HORSHAM DISTRICT COUNCIL CONSULTATION

TO:	Horsham District Council – Planning Dept
LOCATION:	Mowbray Phase RM7 Rusper Road Horsham West Sussex
DESCRIPTION:	Approval of details reserved by conditions 4, 6 and 8 to approved application DC/21/1427
REFERENCE:	DISC/25/0405
RE-CONSULT:	1 st set of comments in black 2 nd set of comments in blue 3 rd set of comments in green
RECOMMENDATION:	Modification Modification / More information Advice

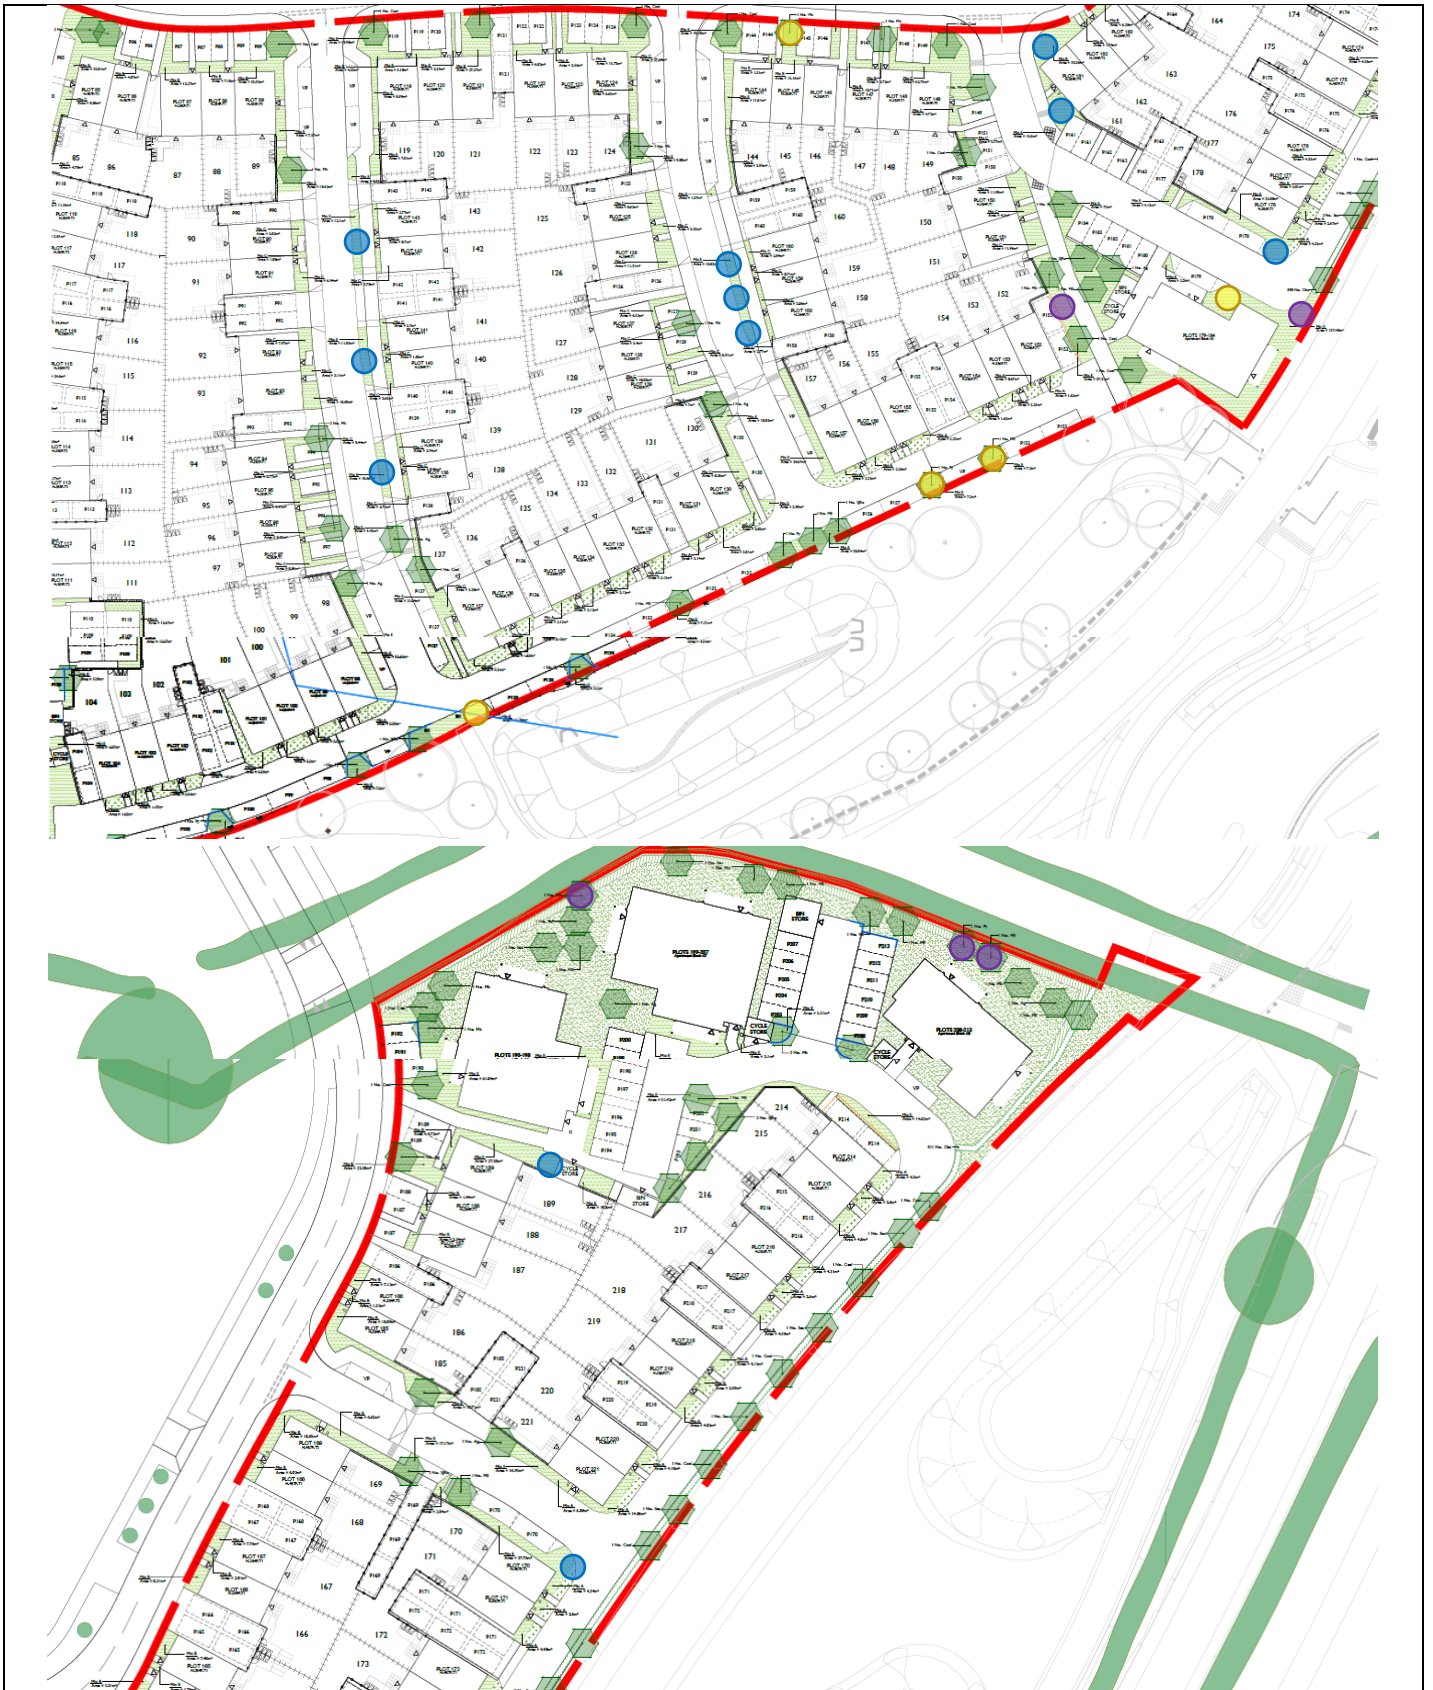
1. While the greater variety in tree species is welcomed, we note that 16no. trees are missing from proposals (please see blue highlights indicating locations below) which must be reinstated.

4no. trees have been removed from the scheme (not inclusive of 5no. relocated trees).
It is strongly encouraged that these are re-instated or relocated elsewhere on site [see yellow highlights indicating removed trees and purple indicated relocated trees].

Further, while not of concern, a drawing error is noted in Sheet 2 (large root barrier spanning the site).

Adjustments to locations notwithstanding, all trees have been reinstated, with thanks.
Closed.
